Consumers
Power
Company

MIDLAND ENERGY CENTER
MIDLAND DOCKET NOS 50-329, 50-330
NRC REQUEST FOR ADDITIONAL INFORMATION ON THE
SEISMIC MARGIN REVIEW REPORT
FILE B3.7.1 SERIAL 29815

ATTACHMENT RESPONSE TO NRC QUESTIONS ON VOLUME VII OF CONSUMERS
POWER COMPANY SEISMIC MARGIN REVIEW REPORT

RESPONSE TO NRC QUESTIONS ON VOLUME VII OF
CONSUMERS POWER CO. SEISMIC MARGIN REVIEW REPORT
DOCKET NOS. 50-329 OM,OL and 50-330 OM,OL

FIGURE 3

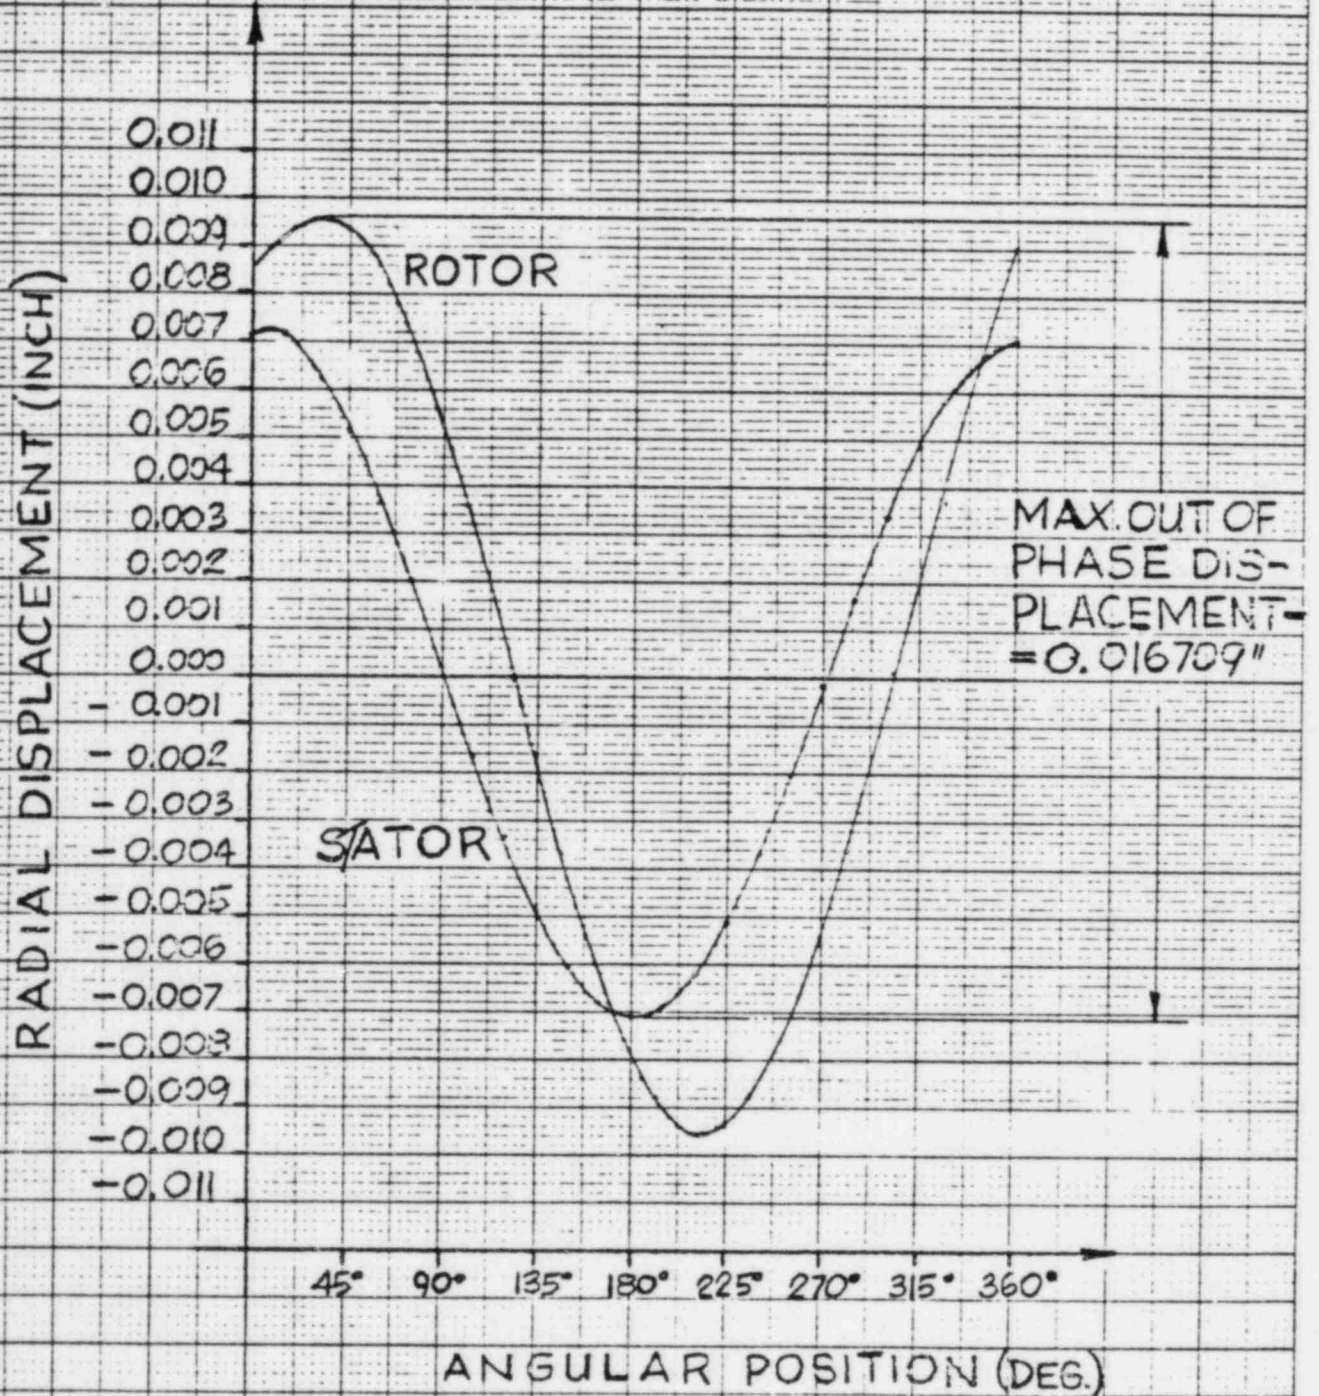
Question (1) Table VII-5-5 Diesel Engine Generator, Part VI. 8.B shows "Max. Critical Deflection" N/A. Explain why this maximum critical deflection was not included, as part of the required assurance of operability.

The Diesel Engine Generator deflection is not the critical SME margin, and was not reported on the basis that only the most critically stressed elements would be addressed. The seismic margin as defined in Volume VII is greater than 21.5.

To illustrate the "SSE" margin, the attached Figure 3 from Delaval Turbine Inc. report 7220-M18-372-1 is attached. From this table, the maximum out-of-phase displacement is 0.0167", while the "air gap" between rotor and stator is stated in the report to be 0.36." Therefore:

$$S.F. (SSE) = \frac{0.36}{0.0167} = 21.56$$

The SME acceleration was enveloped by the SSE acceleration and the S.F. (SME) would be larger than 21.56.

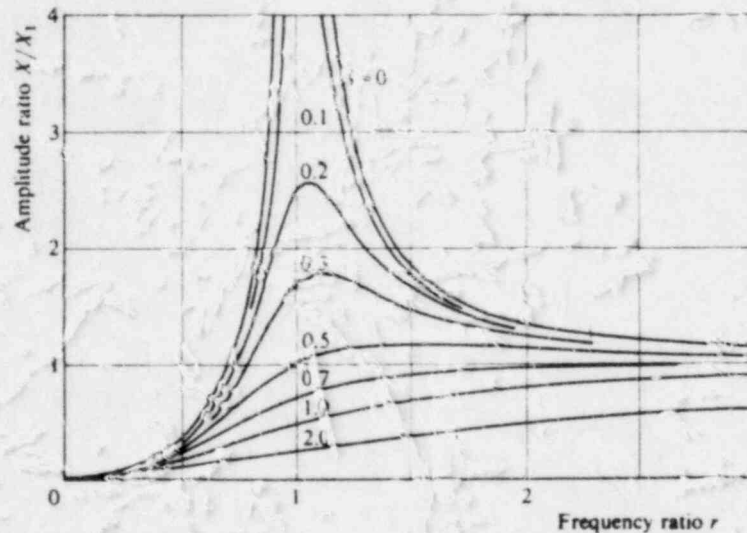
The test, for these cabinets, is described in Appendix A, Table VII-A-9 as multi-axis and multi-frequency. Figure VII-A-9-3 presents the seismic spectra for the side-side/vertical axes of excitation for SME and TRS spectra. This figure shows at the fundamental side-side frequency for the sensor cabinet (6.1 Hz) and the FCCAS cabinet (8.1 Hz), the SME is 1.88 and 2.38, respectively, greater than the TRS accelerations. Clarify the above statement to account for the multi-axis aspect of this test versus the single axis presentation.

As an example, refer to the SME vertical response spectrum plot, Figure VII-9-3. The spectrum shows that although the SME contains significant low frequency motion in the vertical direction, the vertical response of an oscillator with a frequency (vertical) of 35.0 Hz will show only minor amplification. This point is further illustrated by the figure below taken from Mechanical Vibrations, Tse, Morse & Hinkle, 1964.

The figure shows the steady-state response amplification of a single degree-of-freedom oscillator subjected to a harmonic base motion. The frequency ratio, r , is the ratio of the oscillator natural frequency to the forcing function frequency. For the cabinet in question here, the ratio of the vertical fundamental frequency to the frequency at which the SME spectrum is first unenveloped is 3.1. From the figure, it is seen that at a frequency ratio of 3.1, response amplification is negligible. Thus, it can be concluded that the low frequency vertical motion in the SME has negligible importance, and the fact that the SME is not enveloped in this region does not present a qualification concern. Any contribution to the vertical response from this low frequency motion could, therefore, only arise if the horizontal modes (6.1 and 10.7 Hz) have coupled vertical response with large mass participation factors. Large amounts of coupling between horizontal and vertical axes does not exist as demonstrated by the qualification tests.

FIGURE 1. FLOOR RESPONSE SPECTRUM - AUXILIARY BUILDING, ELEVATION 584'-0", EAST-WEST DIRECTION, 1977 MIDLAND PLANT UNITS 1 & 2, 1.0% DAMPING

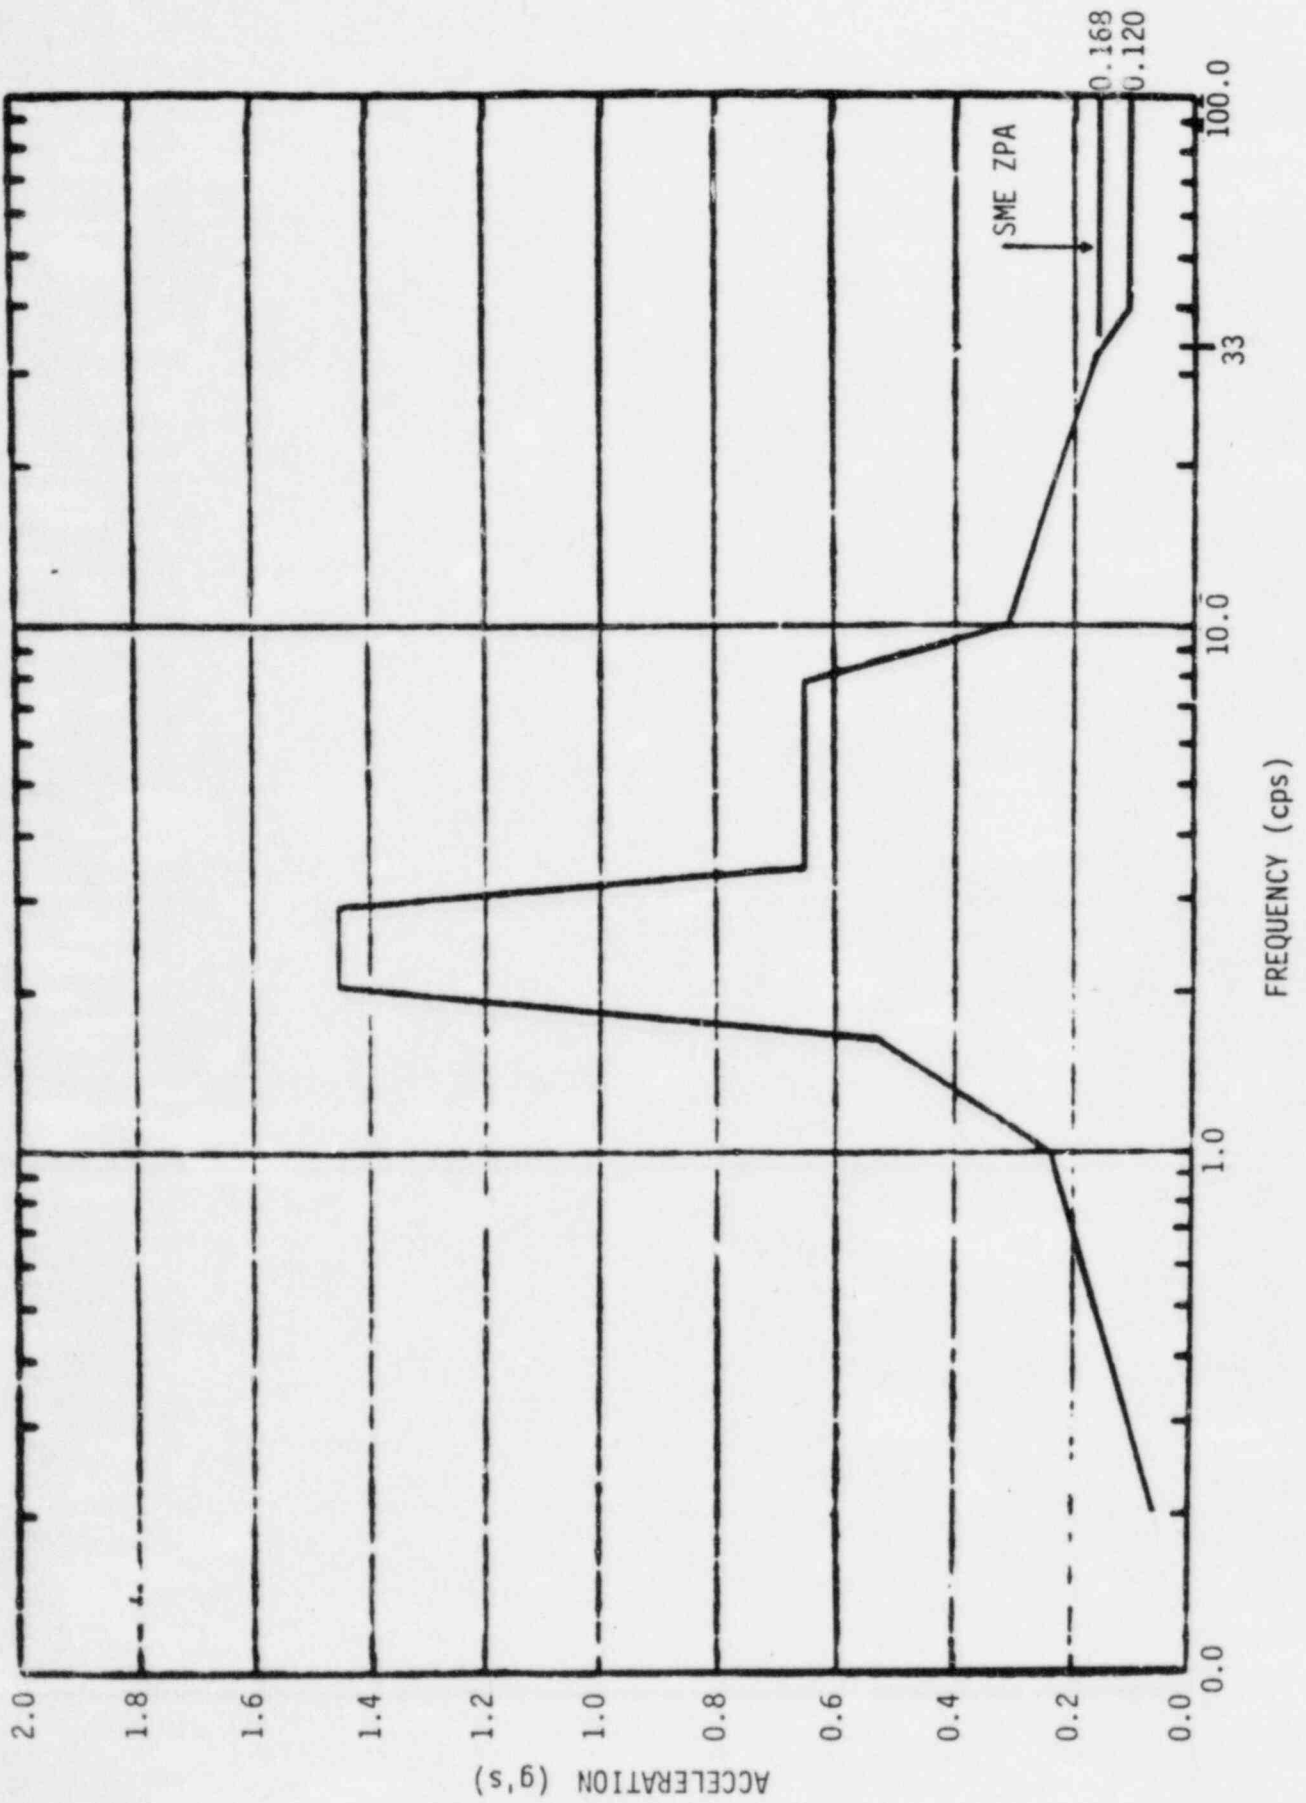
Question (6) Page VII-8-9 for Section 8.7 (Aux. Feedwater Pump - Electric Motor Driven) states: "The SME ZPA's were greater than the design ZPA's in both horizontal directions but were less than the design ZPA in the vertical direction", and for Section 8.8 (Aux. Feedwater Pump - Turbine Driven) states: "The design zero period accelerations in the horizontal directions were less than the corresponding SME accelerations, but the vertical design acceleration was greater than the vertical SME acceleration." Since both of these pumps are located in the Auxiliary Building at Elevation 524'-0", explain why there is a difference in these two statements and present the appropriate horizontal and vertical seismic spectra.

The two statements are the same, although the wording is structured differently, i.e., design ZPA greater than SME ZPA is the same as SME ZPA less than design ZPA. The horizontal and vertical spectra comparisons are enclosed as requested, Figures 1 through 3. Only the ZPA comparisons are made as the pump was determined by analysis to be rigid.
